- A0 TITLE SHEET  
A1 BASEMENT FLOOR PLAN ELEV. 'A'  
A2 PARTIAL BASEMENT FLOOR PLAN ELEV. 'B'  
A3 GROUND FLOOR PLAN ELEV. 'A'  
A4 PARTIAL GROUND FLOOR PLAN ELEV. 'B'  
A5 SECOND FLOOR PLAN ELEV. 'A'  
A6 PARTIAL SECOND FLOOR PLAN ELEV. 'B'  
A7 PART. BASEMENT FLOOR PLAN ELEV. 'C'  
A8 PART. BASEMENT FLOOR PLAN ELEV. 'D'  
A9 PART. GROUND FLOOR PLAN ELEV. 'C'  
A10 PART. GROUND FLOOR PLAN ELEV. 'D'  
A11 PART. SECOND FLOOR PLAN ELEV. 'C'  
A12 PART. SECOND FLOOR PLAN ELEV. 'D'  
A13 FRONT ELEVATION 'A'  
A14 FRONT ELEVATION 'B'  
A15 REAR ELEVATION 'B & D'  
A16 REAR ELEVATION 'A & C'  
A17 RIGHT SIDE ELEVATION 'B'  
A18 LEFT SIDE ELEVATION 'A'  
A19 FRONT ELEVATION 'C'  
A20 FRONT ELEVATION 'D'  
A21 RIGHT SIDE ELEVATION 'D'  
A22 LEFT SIDE ELEVATION 'C'  
A23 TYPICAL CROSS SECTION - SEMI (BRICK)  
A24 PARTIAL BASEMENT FLOOR PLAN ELEV. 'A' & 'B'

client	
Gold Park Homes	
project	
McLaughlin and Mayfield	
model	
SD-3 Brampton	
project #	
13098	
scale	
3/16" = 1'0"	
lot(s)

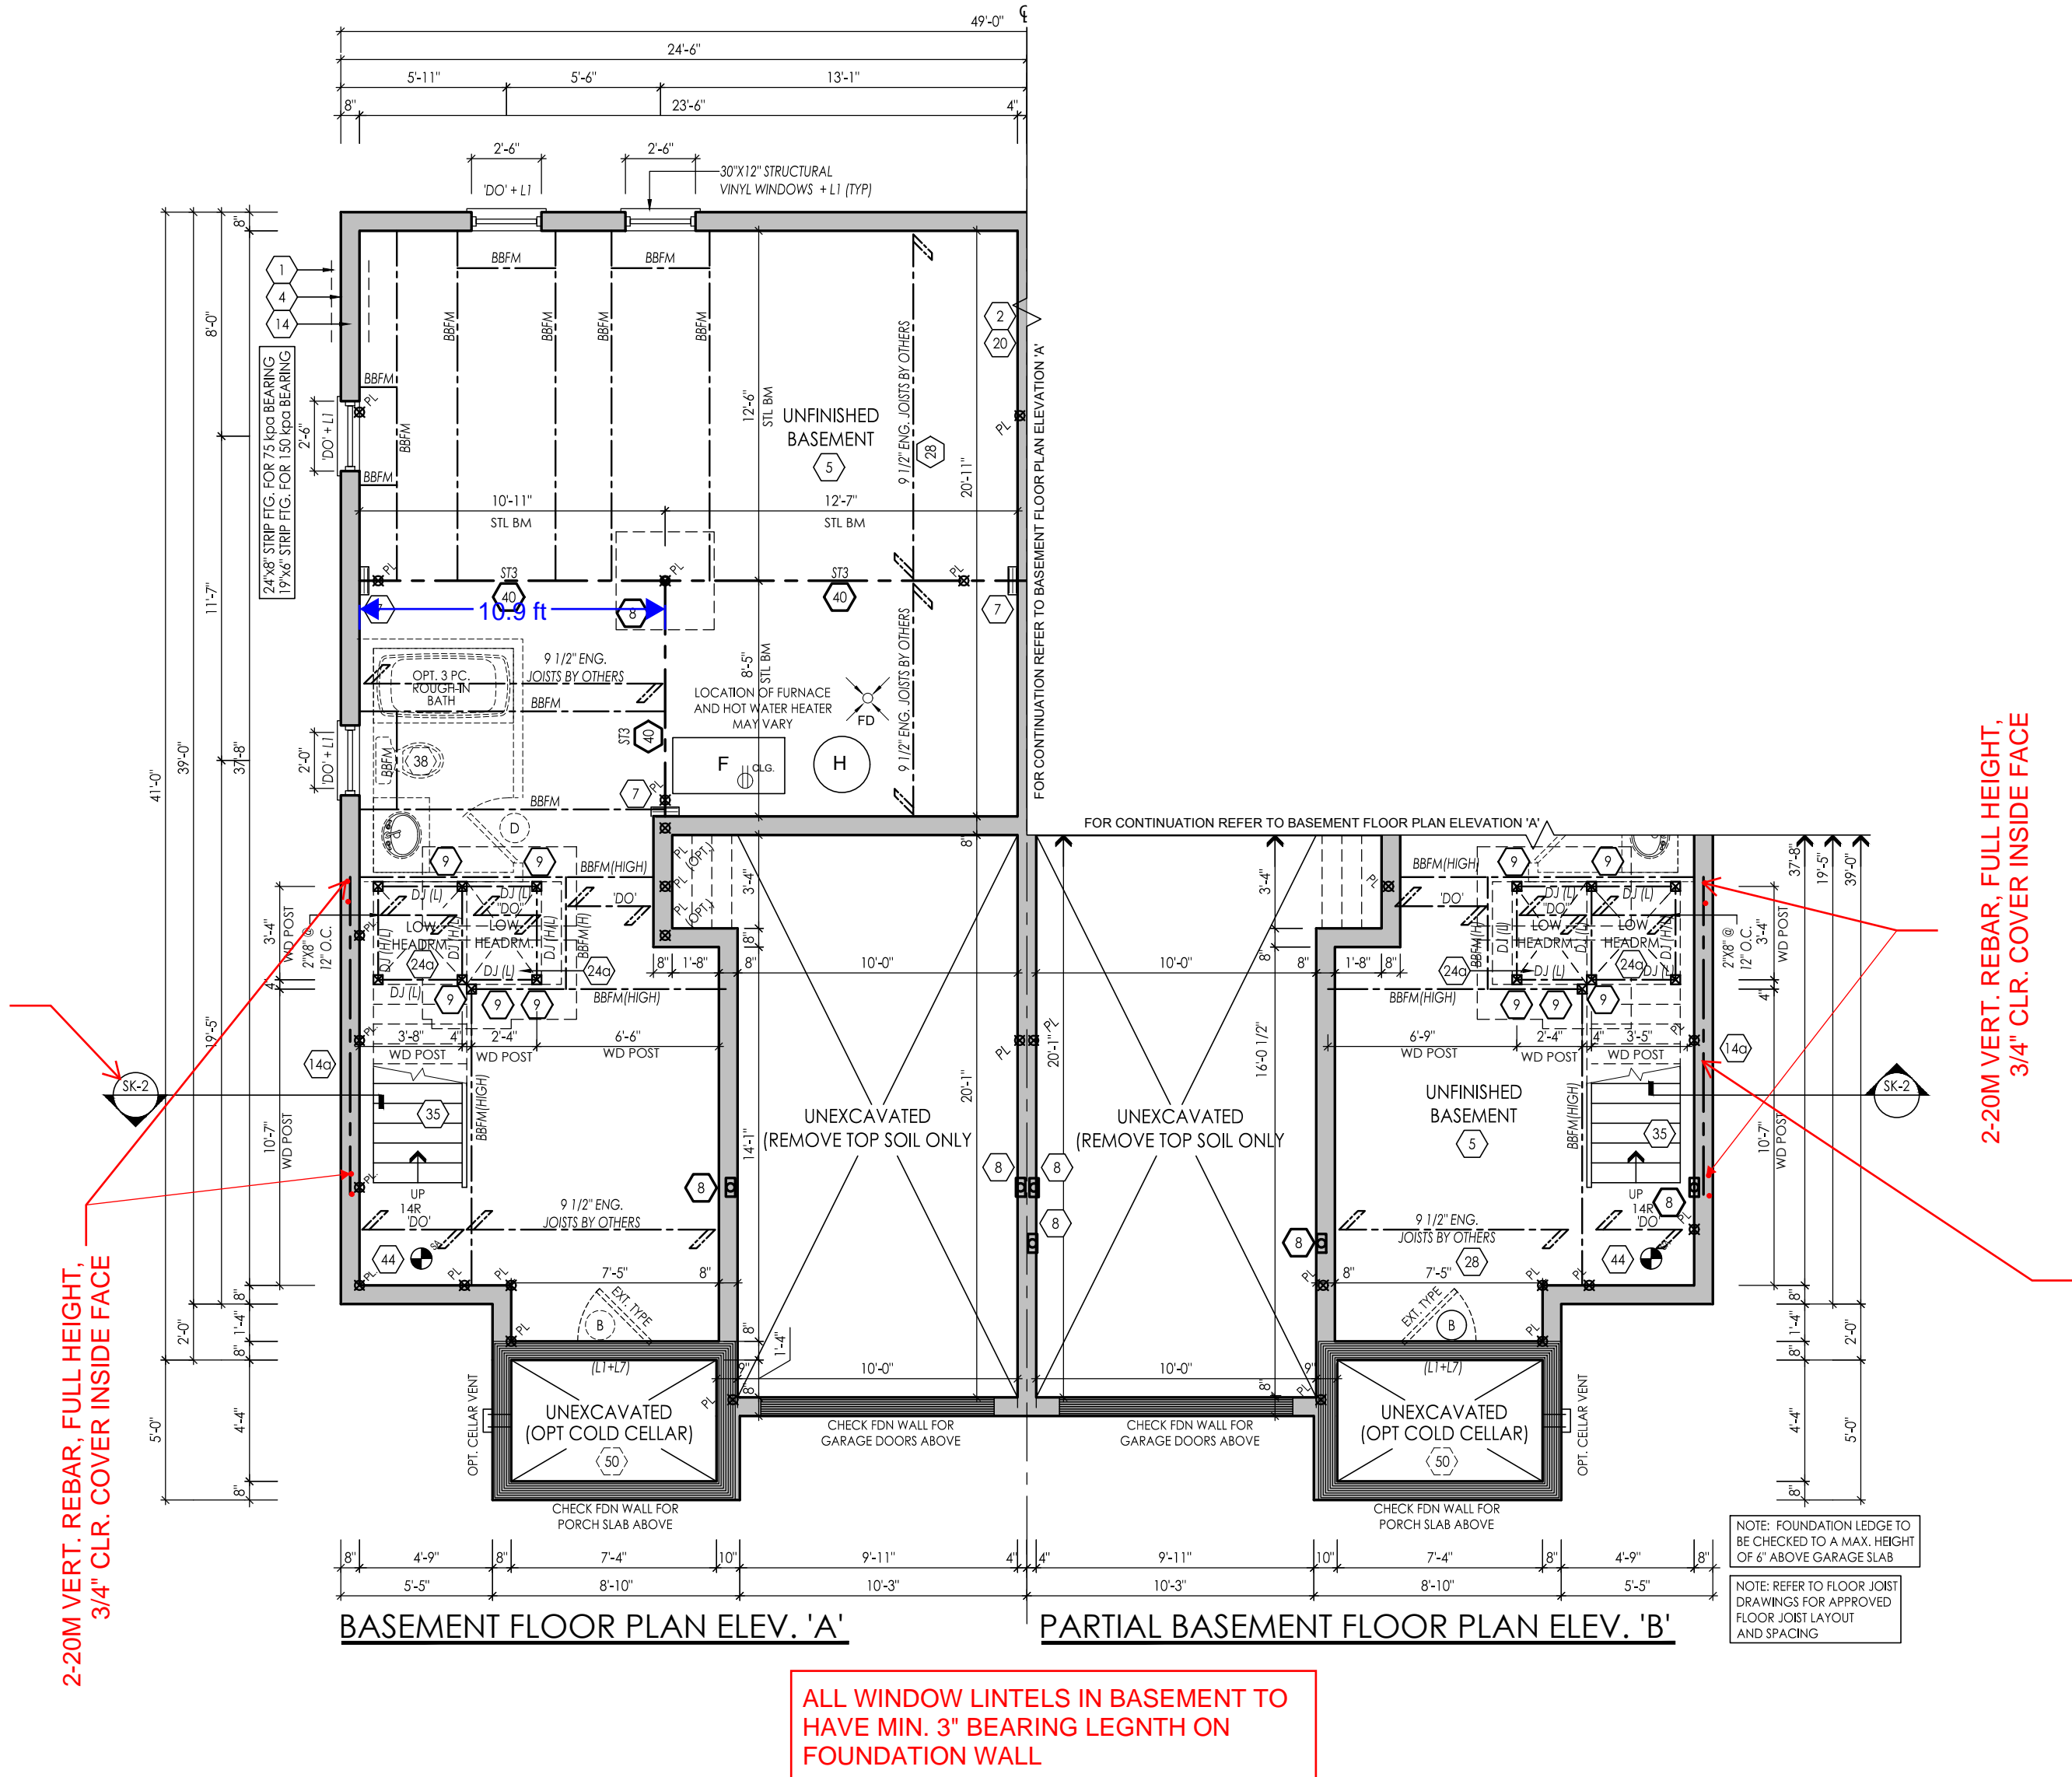
REPLACE SECTION SK-2 WITH THE FOLLOWING TEXT:  
4-20M LONG. CONT. BAR @ TOP OF WALL,  
2 EACH FACE, 6" VERT. SPACING, EXT. 2'-0" BEYOND  
OPENING,  
2" CLR. COVER OUTSIDE FACE,  
3/4" CLR. COVER INSIDE FACE

2-20M VERT. REBAR, FULL HEIGHT,  
3/4" CLR. COVER INSIDE FACE

2-20M VERT. REBAR, FULL HEIGHT,  
3/4" CLR. COVER INSIDE FACE

REPLACE SECTION SK-2 WITH THE FOLLOWING TEXT:  
4-20M LONG. CONT. BAR @ TOP OF WALL,  
2 EACH FACE, 6" VERT. SPACING, EXT. 2'-0" BEYOND  
OPENING,  
2" CLR. COVER OUTSIDE FACE,  
3/4" CLR. COVER INSIDE FACE

A4

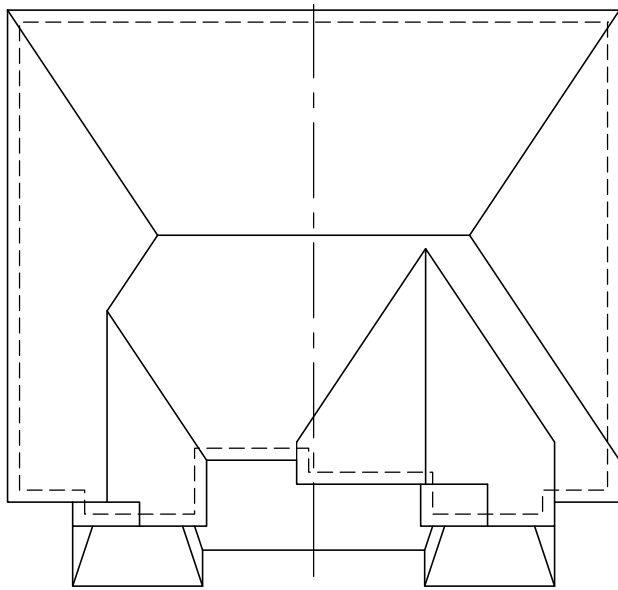
REPLACE SECTION SK-2 WITH THE FOLLOWING TEXT:  
4'-20M LONG. CONT. BAR @ TOP OF WALL,  
2 EACH FACE, 6" VERT. SPACING, EXT. 2'-0" BEYOND  
OPENING.  
2" CLR. COVER OUTSIDE FACE,  
3/4" CLR. COVER INSIDE FACE,

2-20M VERT. REBAR, FULL HEIGHT,  
3/4" CLR. COVER INSIDE FACE

2" CLR. COVER OUTSIDE FACE,  
3/4" CLR. COVER INSIDE FACE

2-20M VERT. REBAR, FULL HEIGHT,  
3/4" C.R. COVER INSIDE FACE

REPLACE SECTION SK-2 WITH THE FOLLOWING TEXT:  
4'-20M LONG. CONT. BAR @ TOP OF WALL.  
2 EACH FACE, 6" VERT. SPACING, EXT. 2'-0" BEYOND  
OPENING.  
2" CLR. COVER OUTSIDE FACE,  
3/4" CLR. COVER INSIDE FACE.
